Dean Moor Solar Farm

Environmental Statement: Chapter 7 – Figure 7.6 1-5 Landscape Strategy Plan on behalf of FVS Dean Moor Limited

26 August 2025
Prepared by: Stantec UK Ltd
PINS Ref: EN010155
Document Ref: D2.28
Deadline: 2
Revision: 2

Figure: 7.6.3

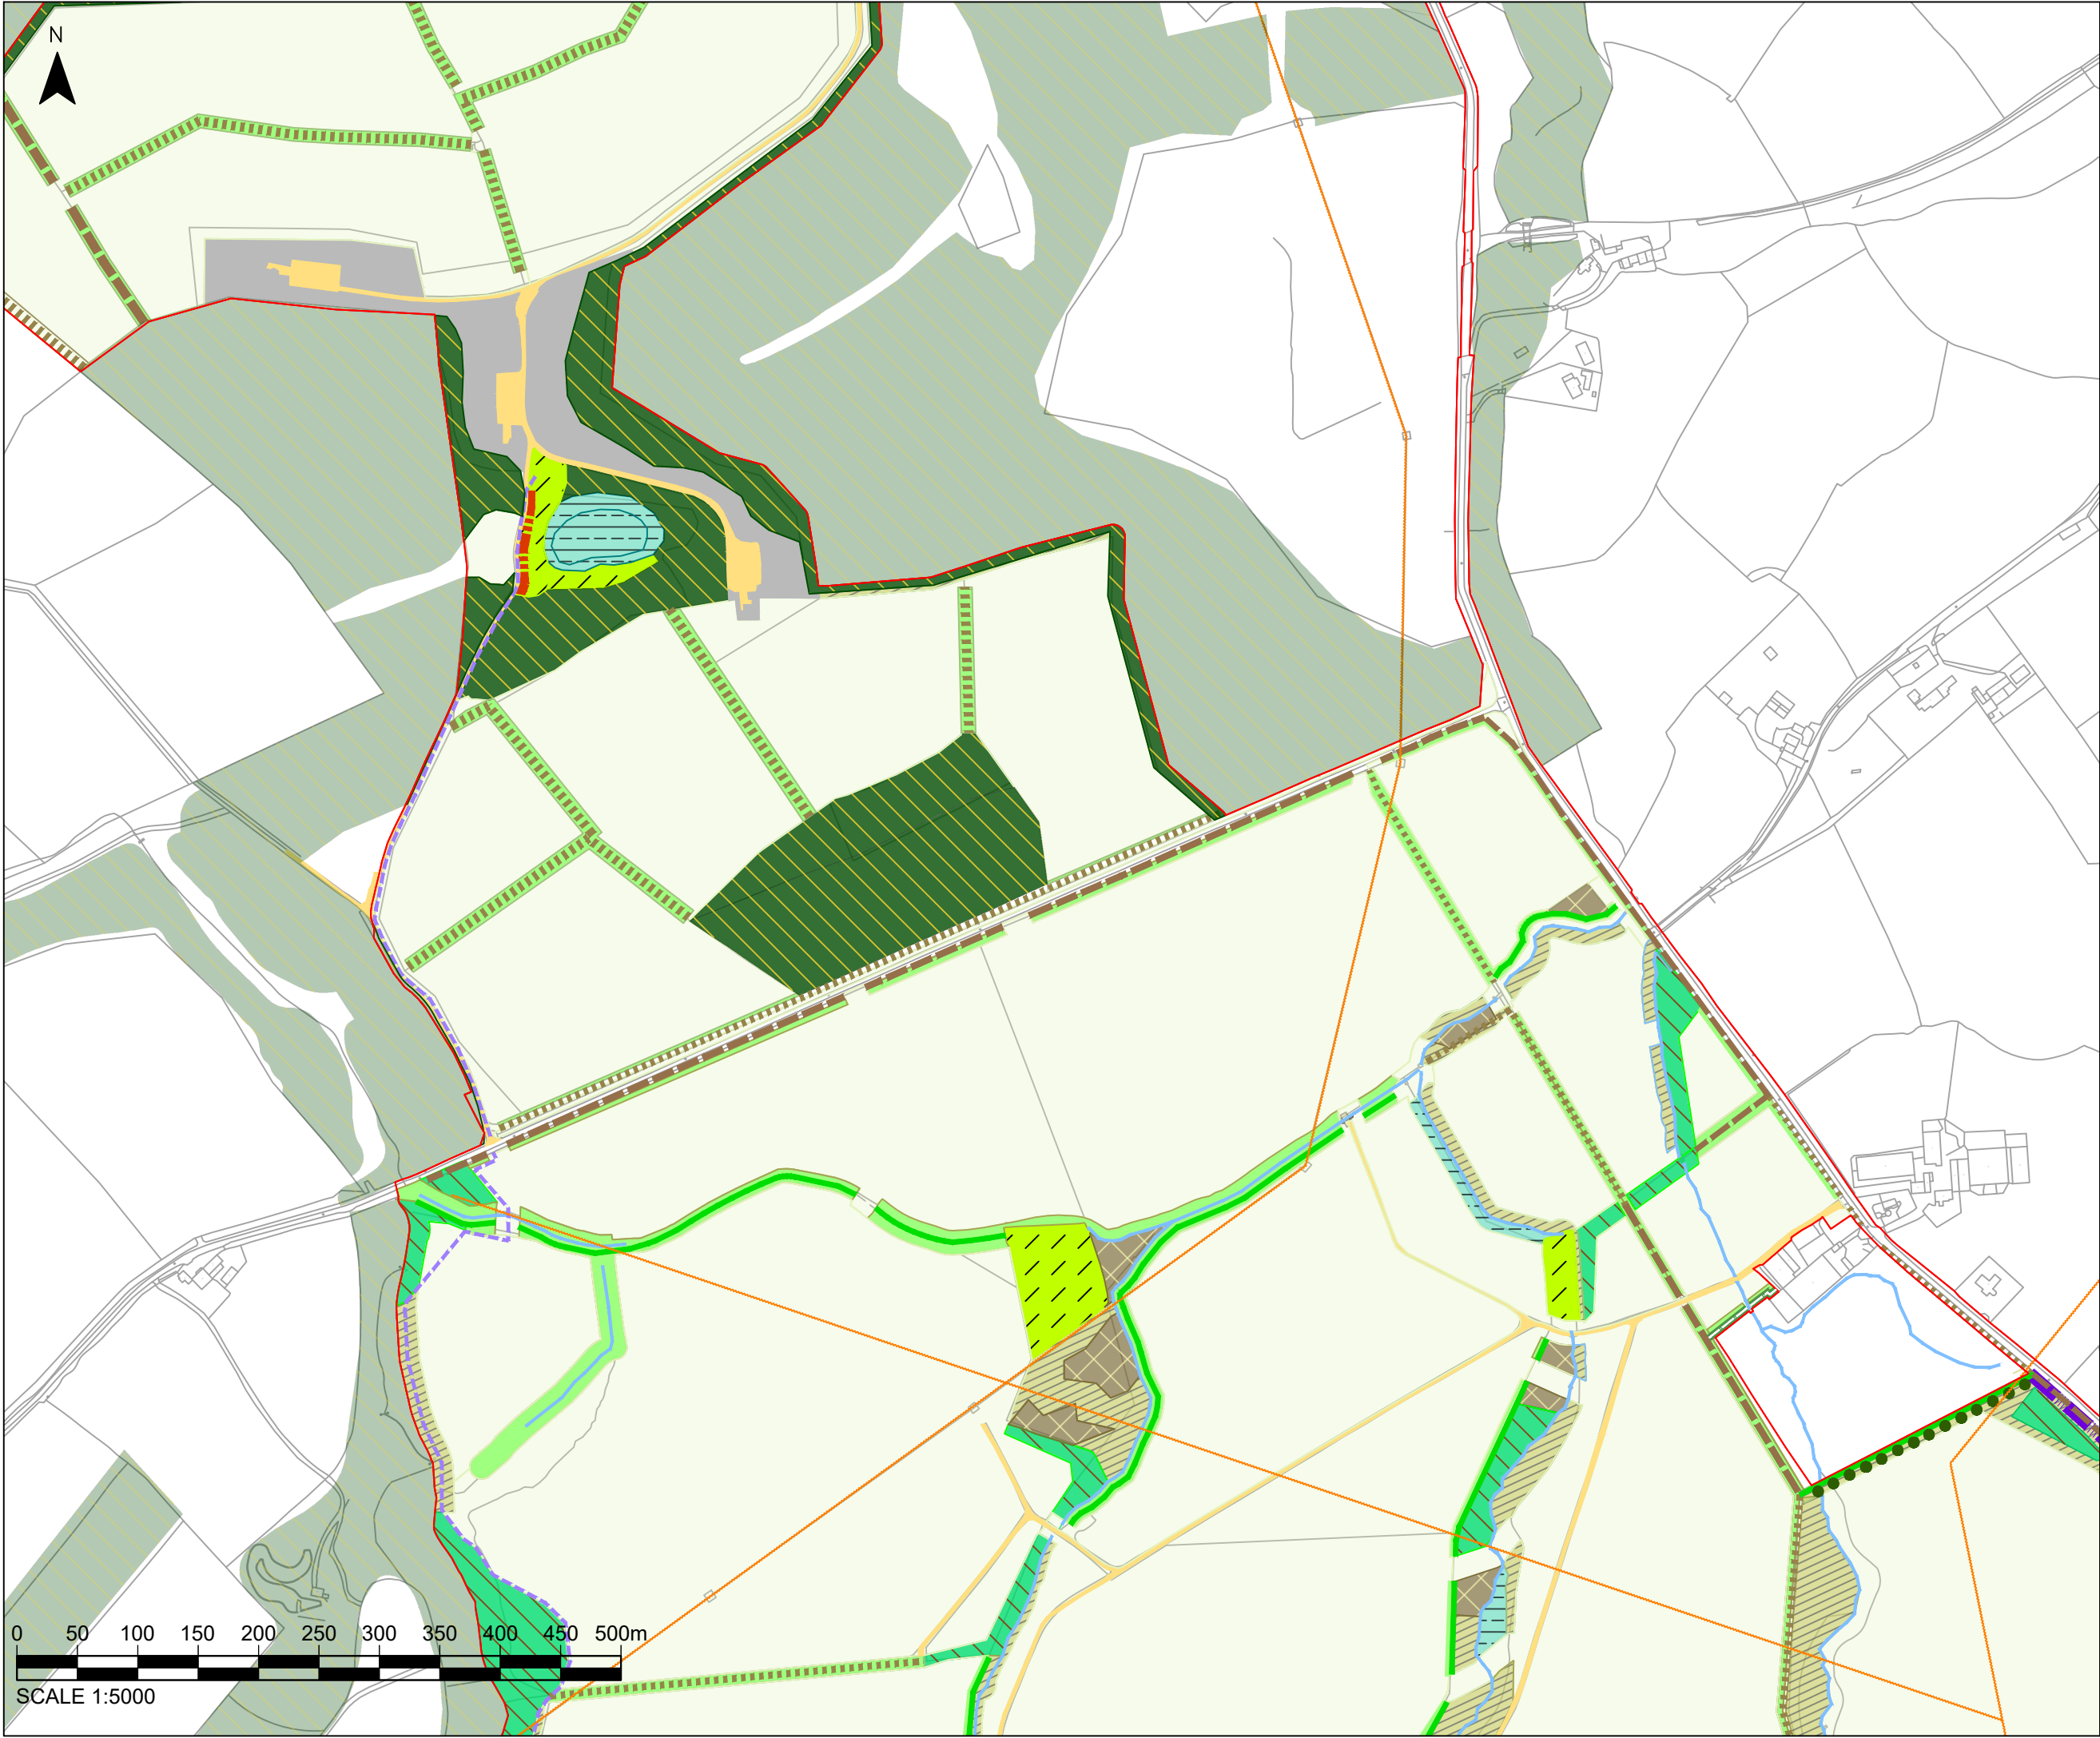
B	GRAPHIC AMENDMENTS TO LINETYPES/HATCHES	IM	AC	2025.08.12
A	FIRST ISSUE	MB	AC	2025.01.14
Issued/Revision		By	Appd	YYYY.MM.DD

Figure: 7.6.4

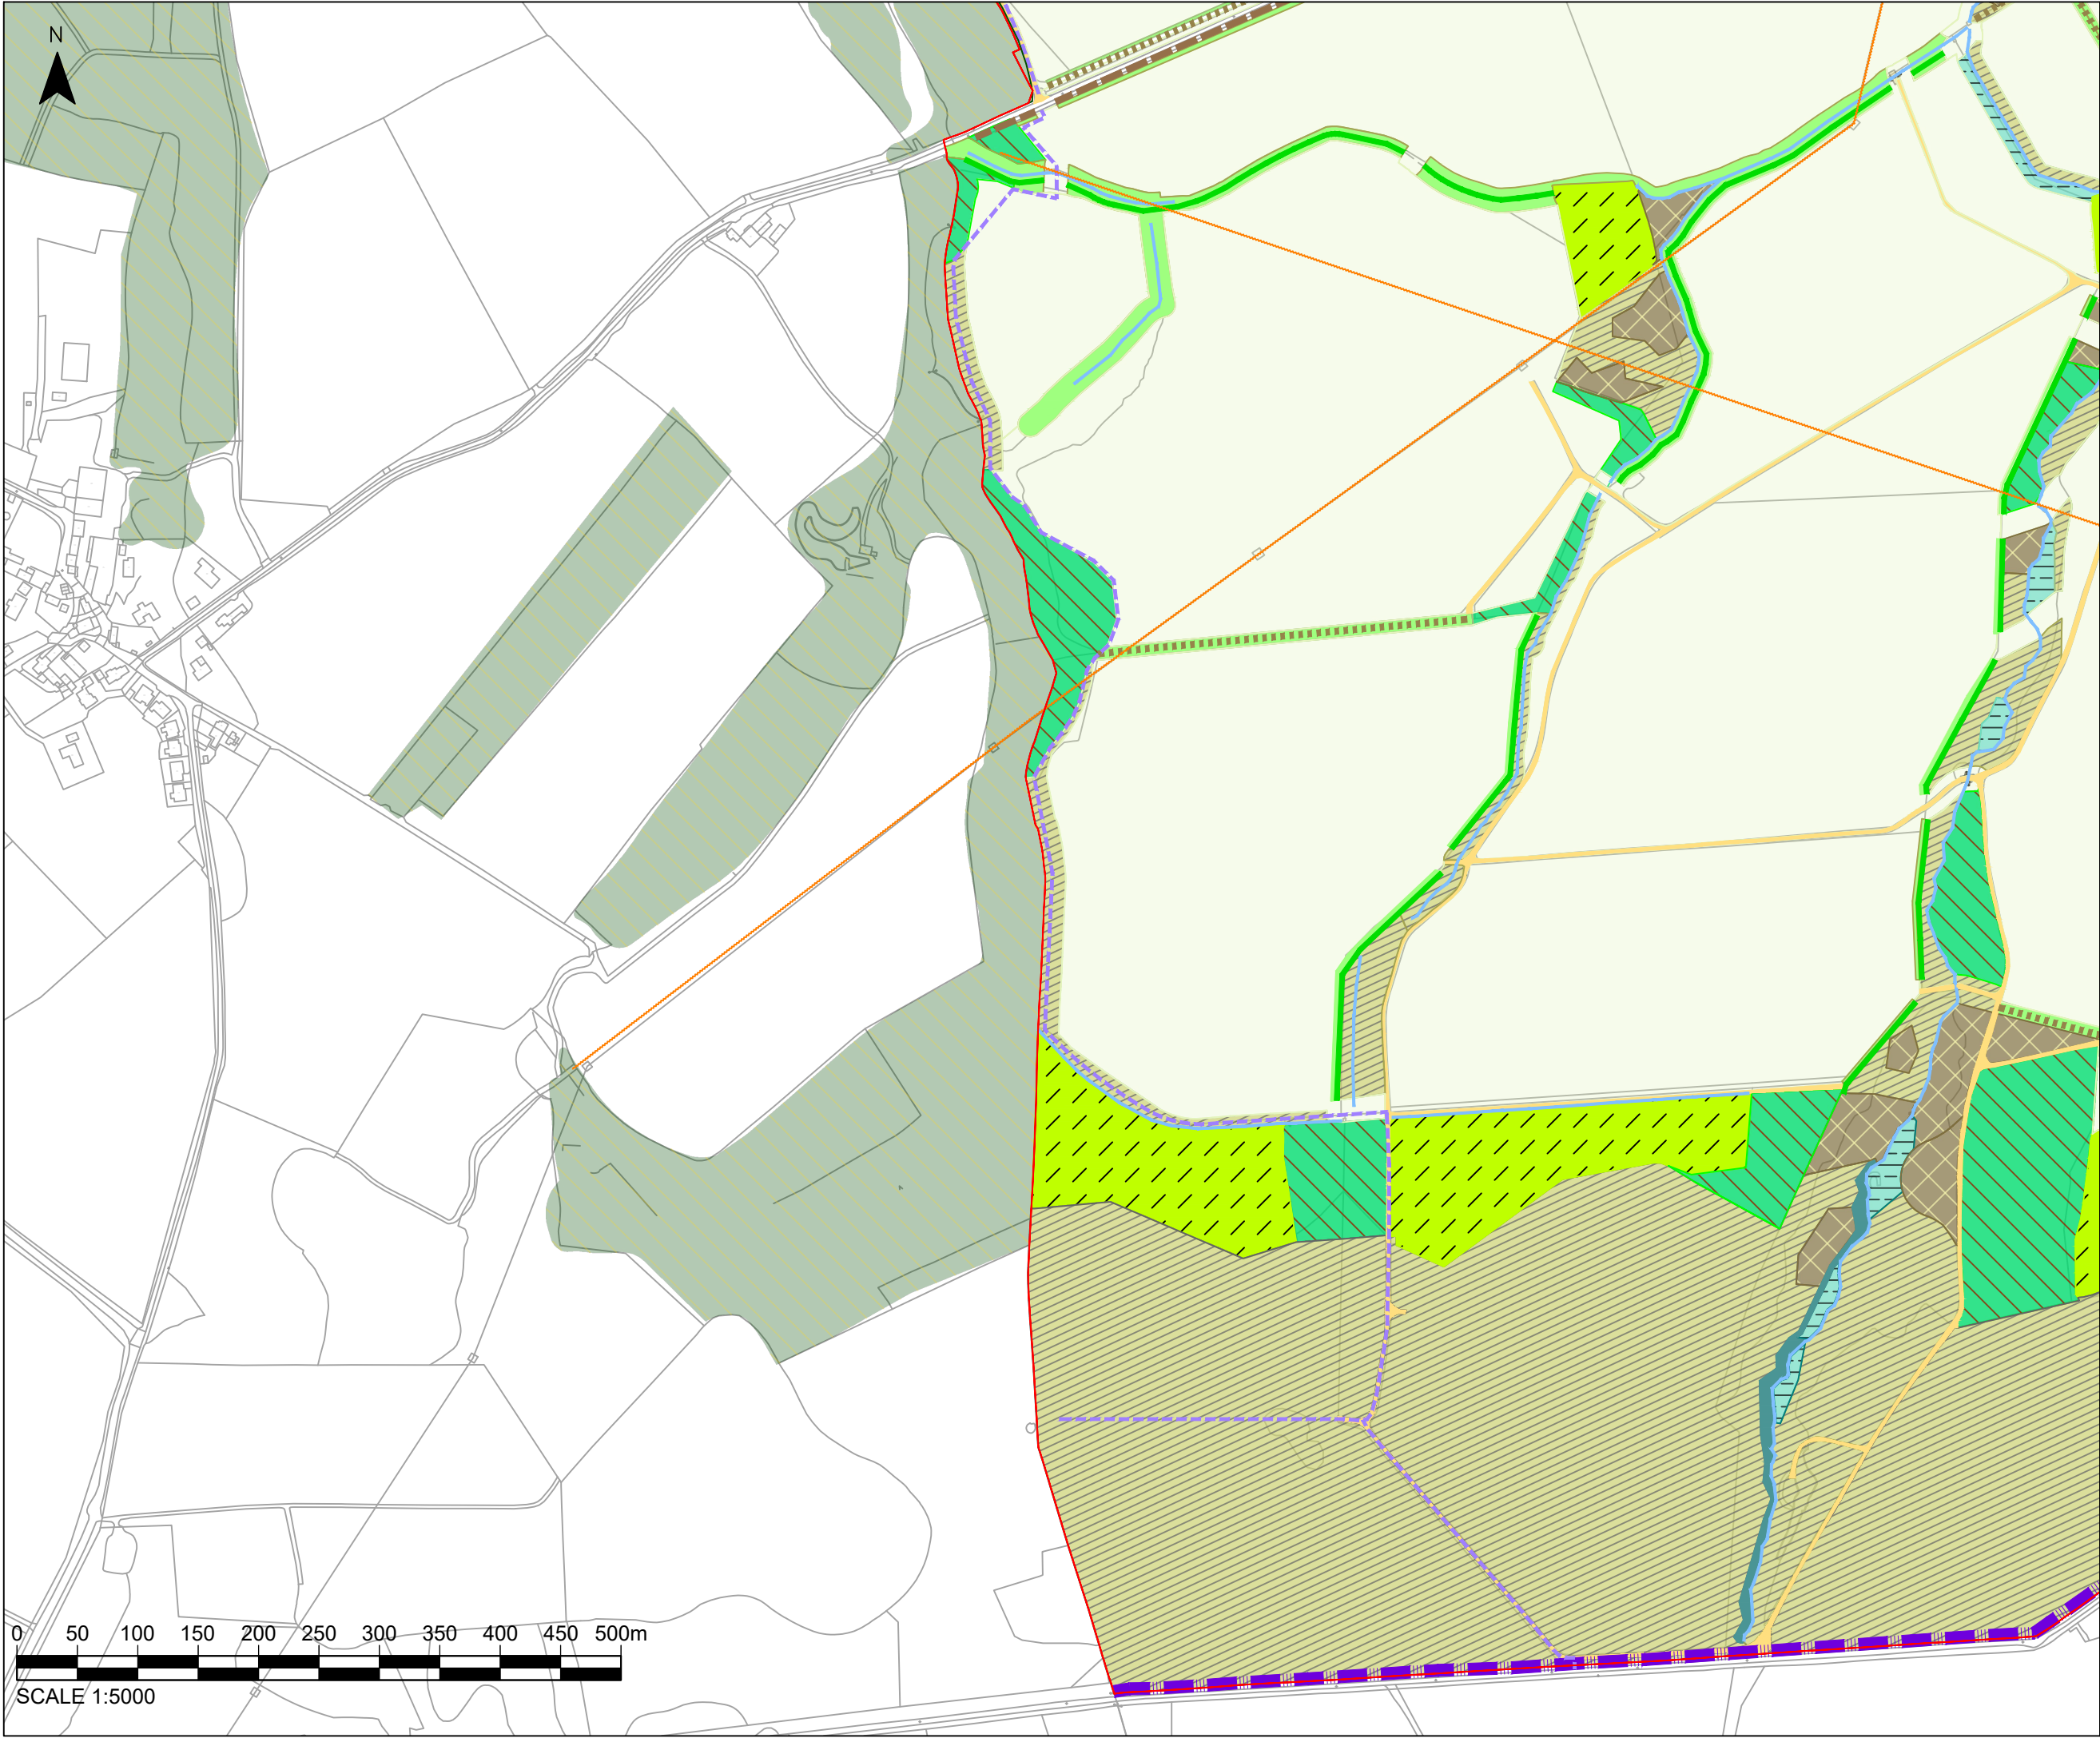
B	GRAPHIC AMENDMENTS TO LINETYPES/HATCHES	IM	AC	2025.08.12
A	FIRST ISSUE	MB	AC	2025.01.16
Issued/Revision		By	Appd	YYYY.MM.DD

Figure: 7.6.5

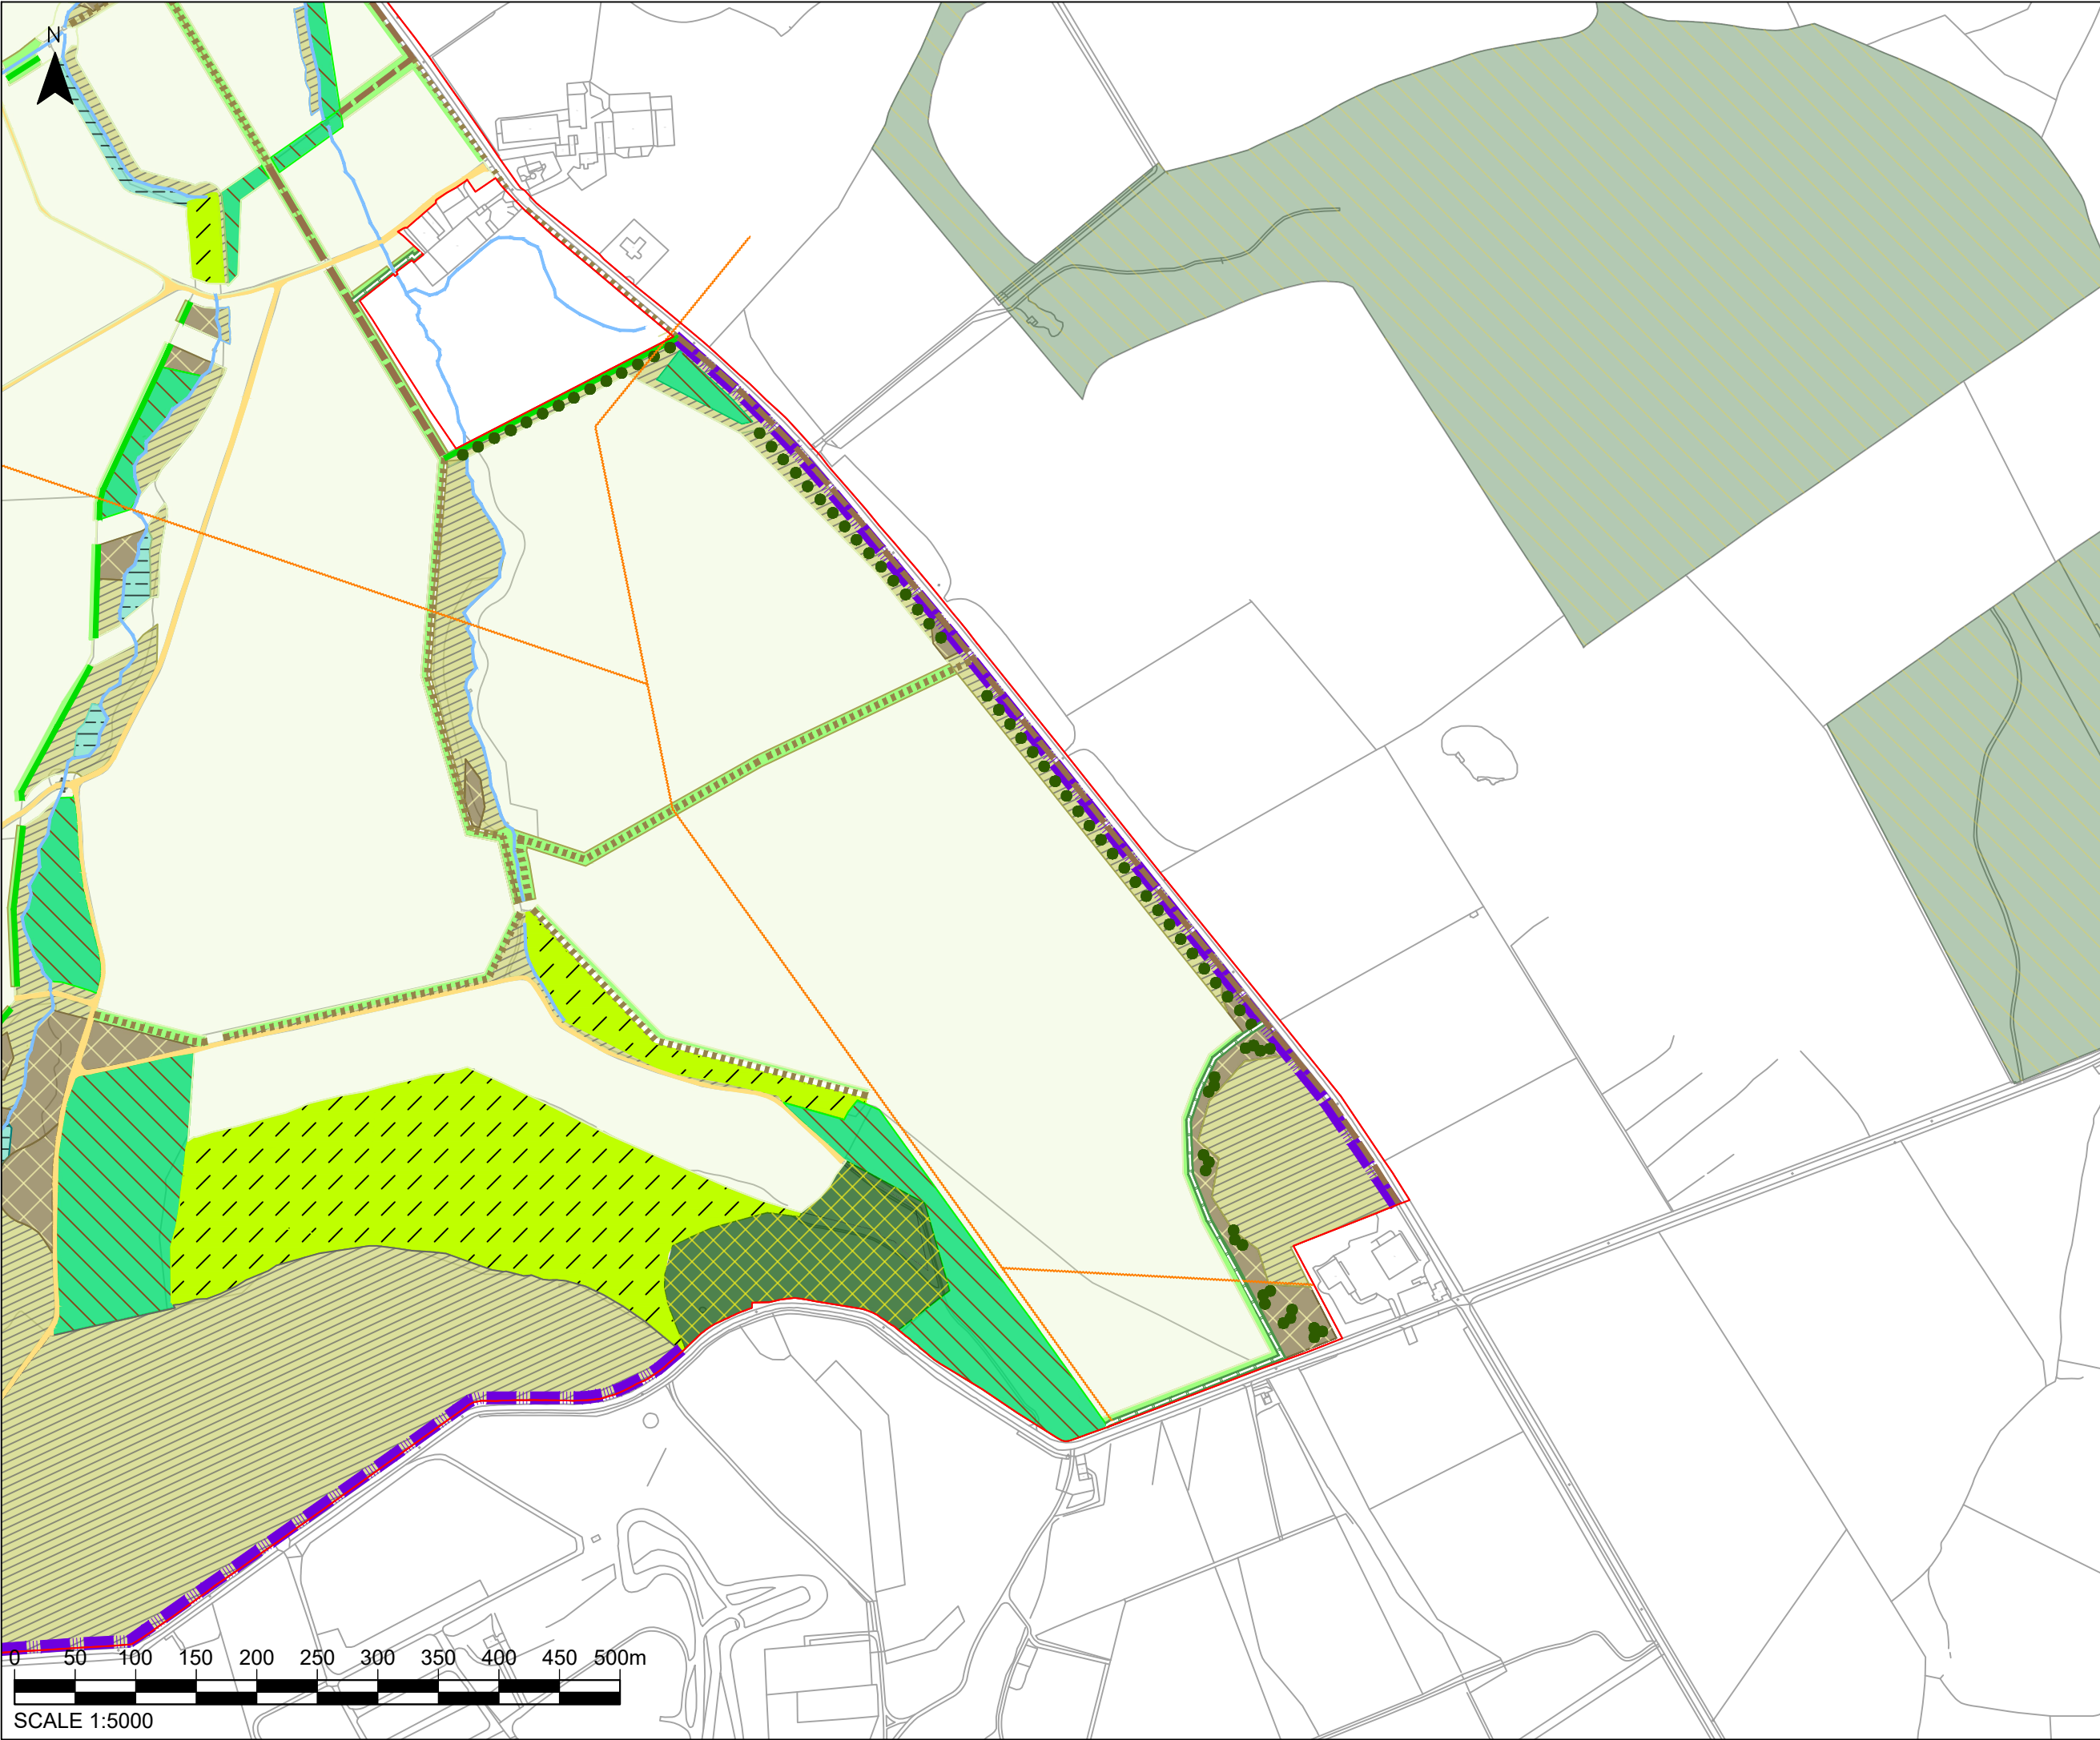
B	GRAPHIC AMENDMENTS TO LINETYPES/HATCHES	IM	AC	2025.08.12
A	FIRST ISSUE	MB	AC	2025.01.16
Issued/Revision		By	Appd	YYYY.MM.DD
